Early Grading Permit - Final Drainage Report

Overlook at Homestead Subdivision Filing No. 1 El Paso County, Colorado

EGP241

Prepared: January 24, 2024

OVERLOOK FILING NO. 1
 EL PASO COUNTY, COLORADO
 PRELIMINARY DESIGN PLANS
 PROPOSED DRAINAGE MAP

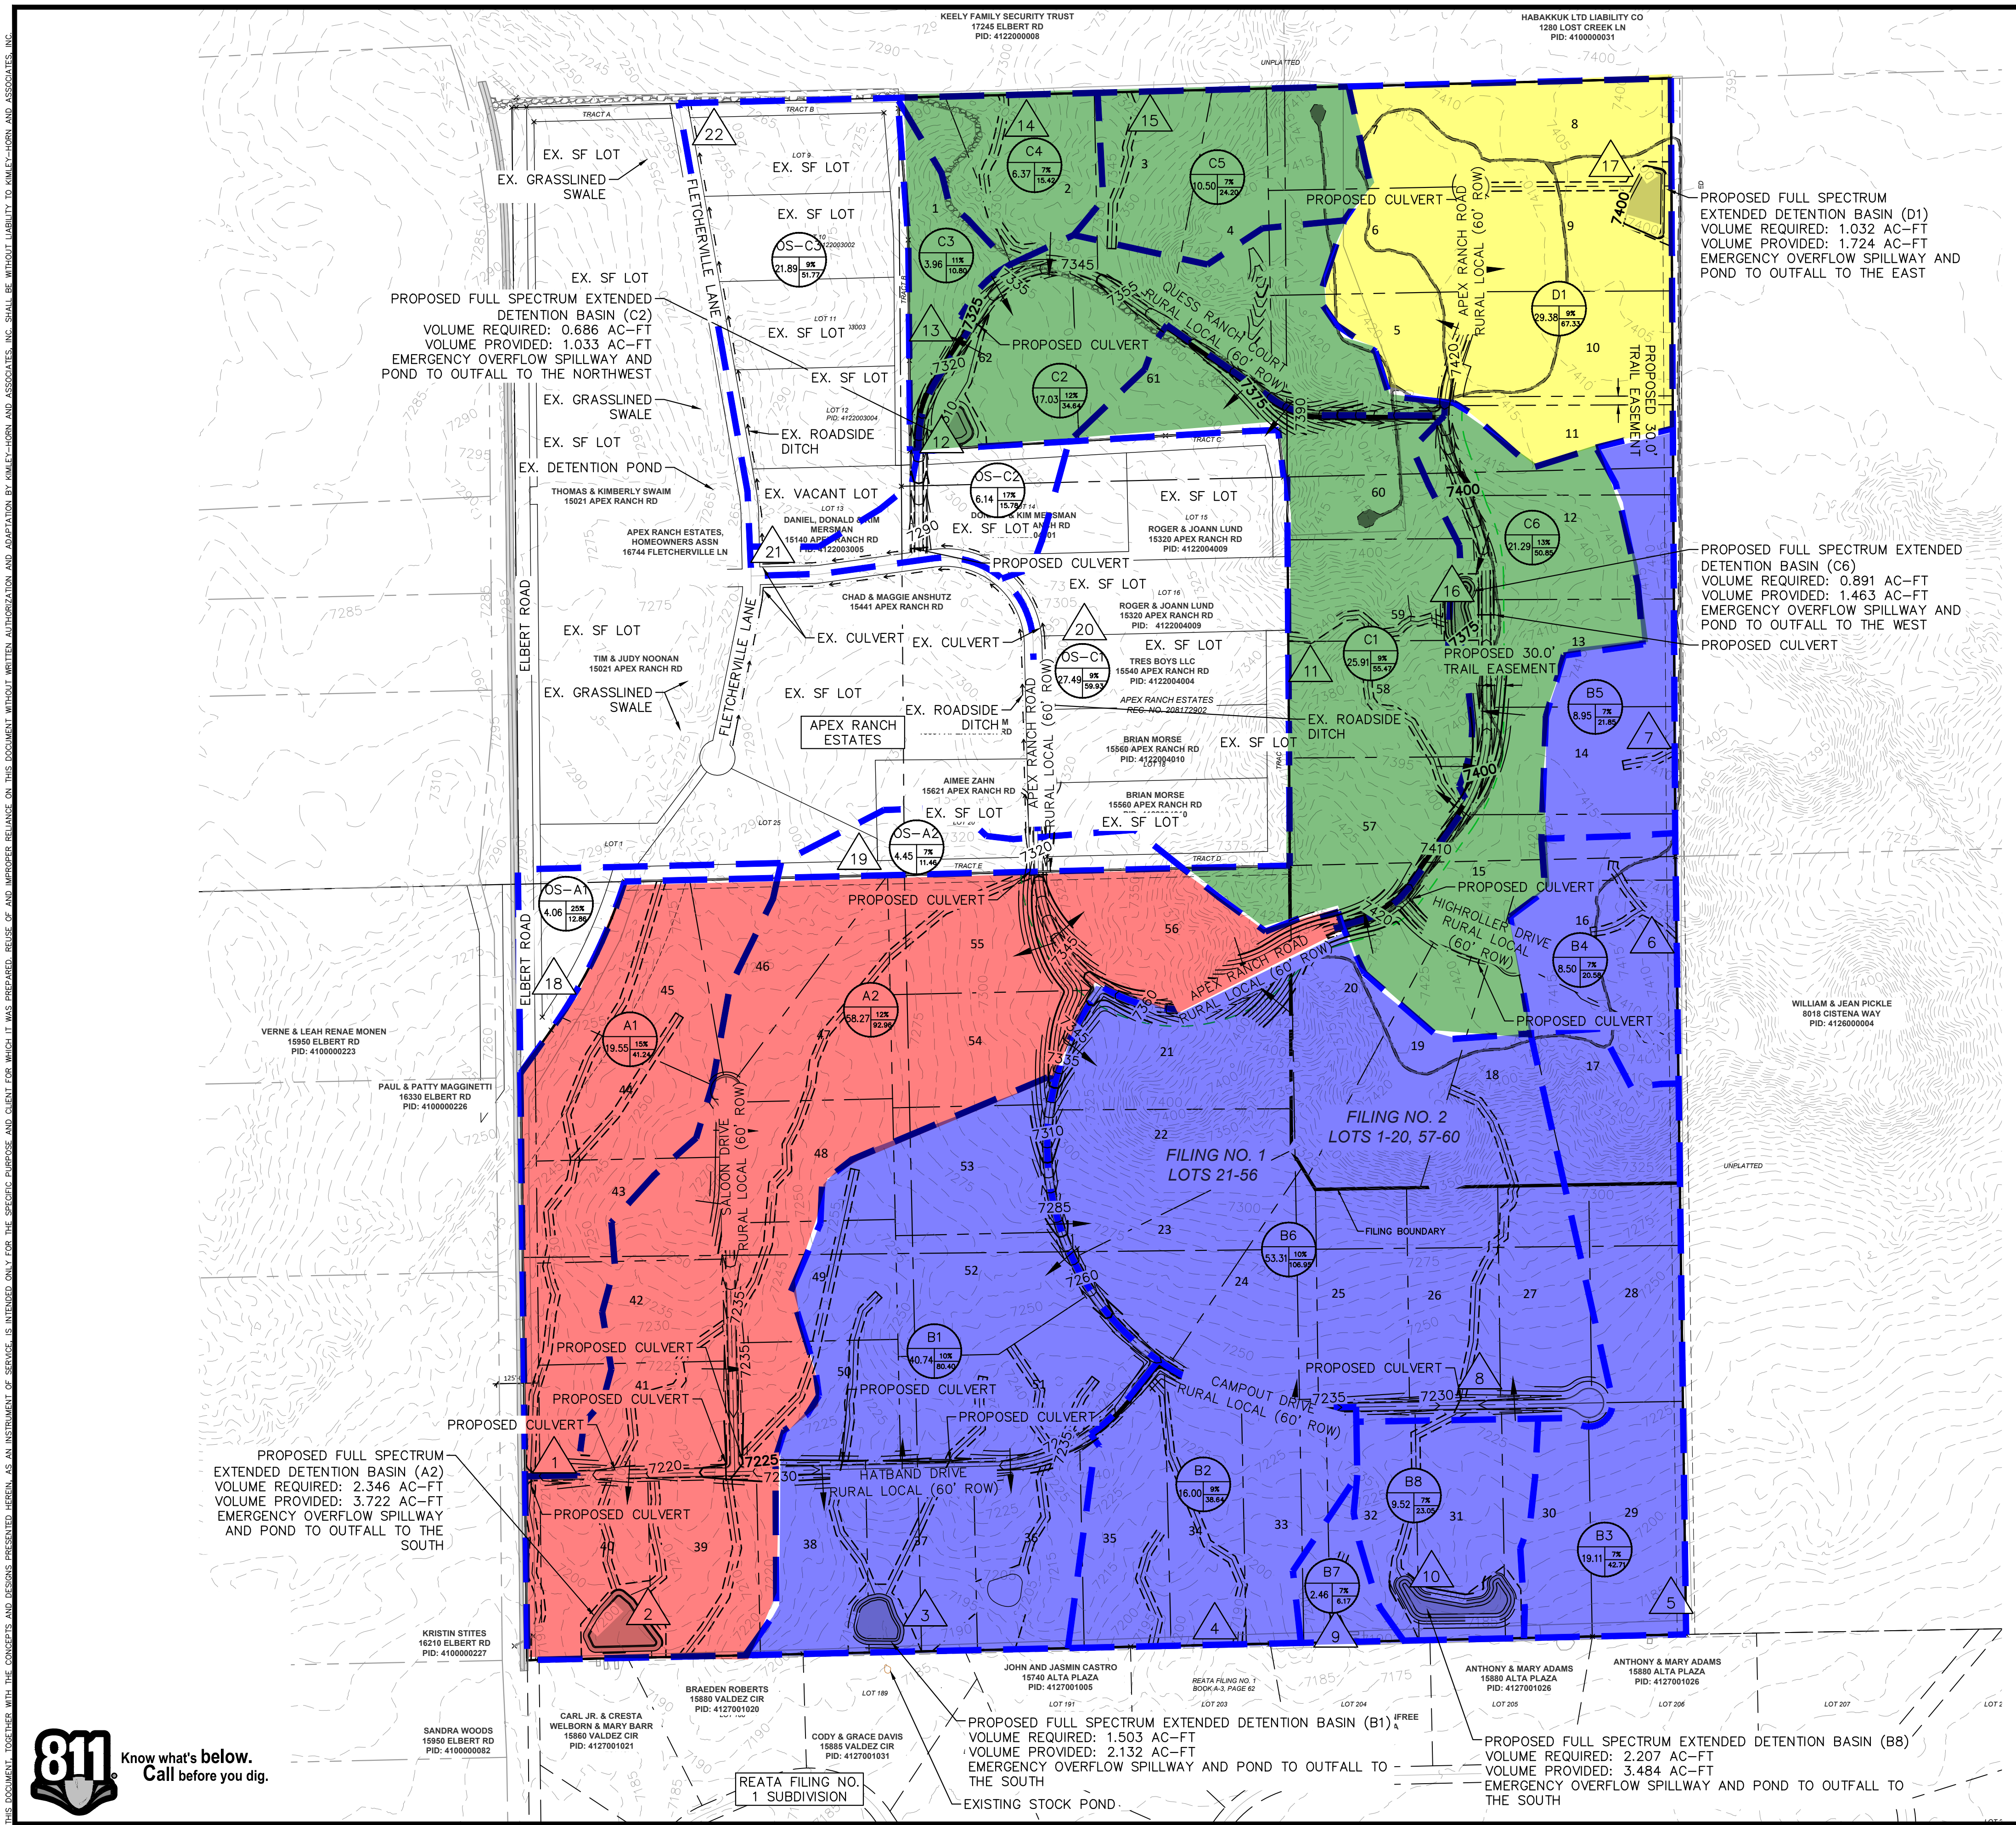
Please show and label all storm pipes including but not limited to type, size, and conditions.

Please show and label storm flow directions on all drainage maps.

Note as mentioned in the PRELIM Plan PDR all temp and permanent ponds must be located back from the property boundaries to accommodate the outlets structures necessary and emergency overflows. Ensure next submittal shows these details.

Please label three pond as temporary ponds to match the text discussion and grading erosion control plan.

Please revise basin boundary to include the total disturbance areas to match the GEC plan.

Please ensure that Filling 2 is not included in the current project. Provide a bound or shade it in a light color. Additional include a note to clarify this.

Please show and label ripraps with type, size, IDs that match the calculations.

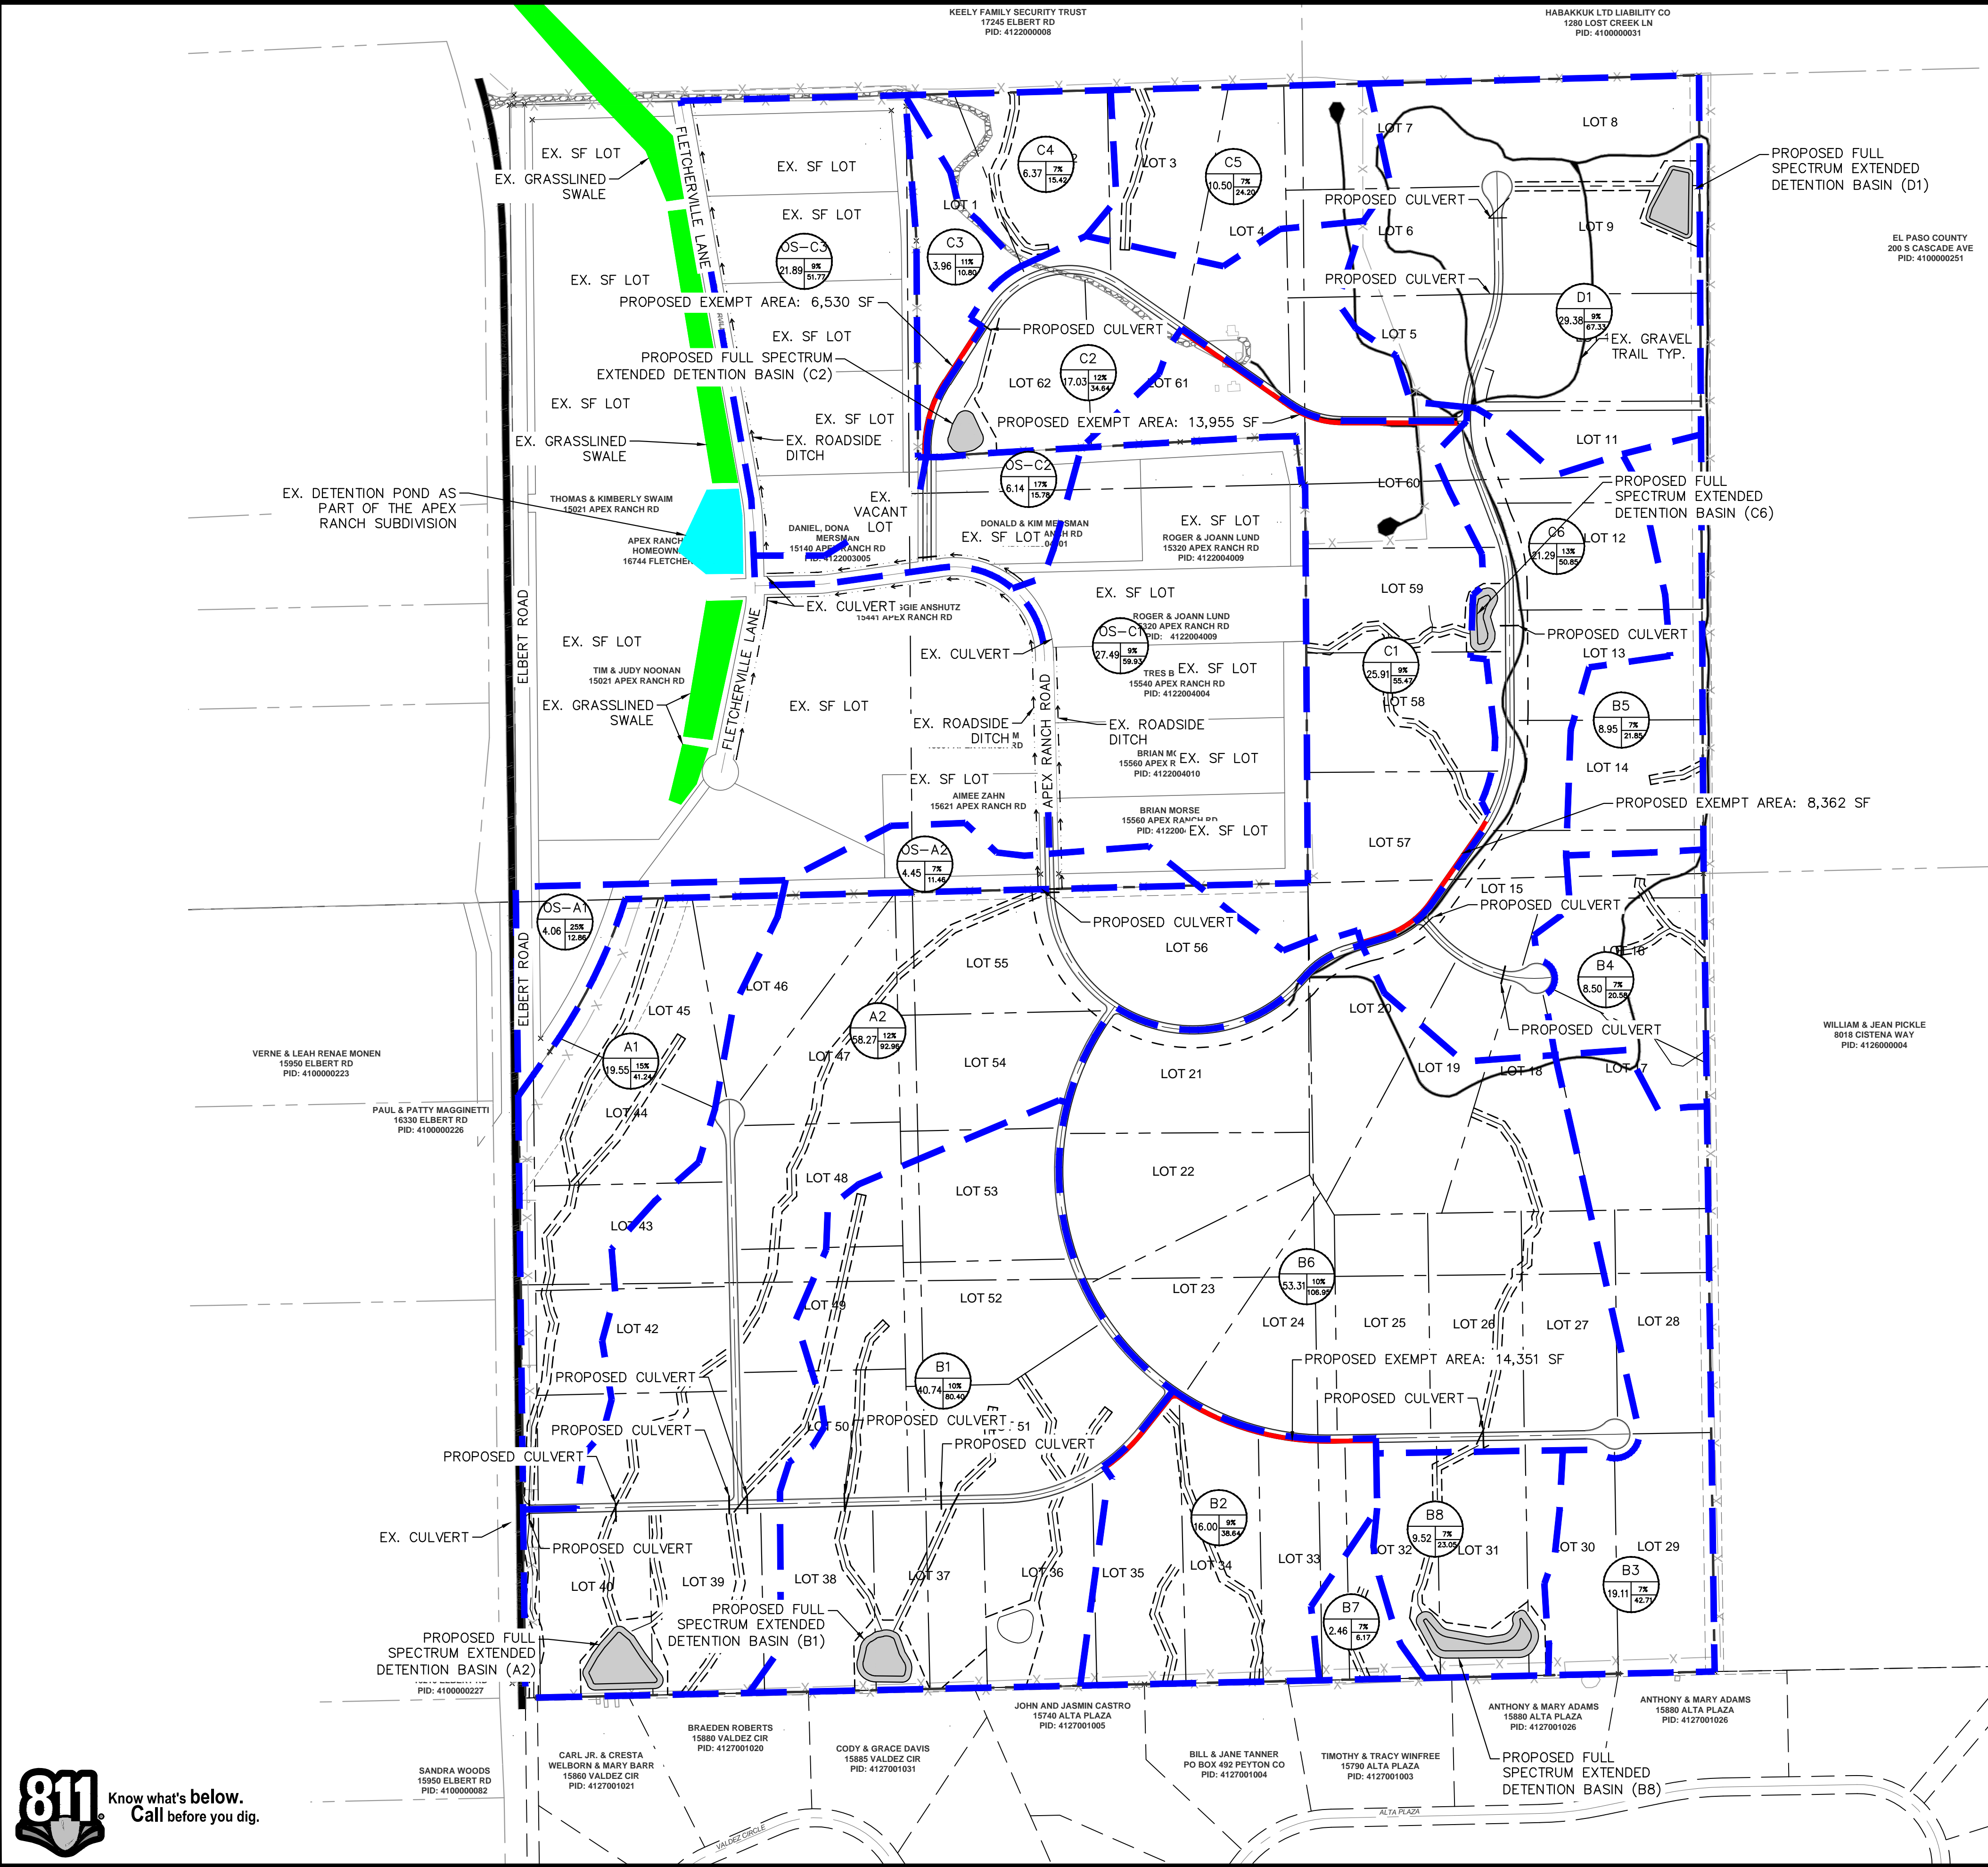
Please create a basic overview map (or modify an existing drainage map) with color shading/hatching that shows areas tributary to each PBMP (pond, runoff reduction, etc.) and those disturbed areas that are not treated by a PBMP, with the applicable exclusion labeled (ex: 20% up to 1ac of development can be excluded per ECM App I.7.1. C.1 and exclusions listed in ECM App I.7.1.B.#). Show what areas drain to each proposed TSB and what are excluded.
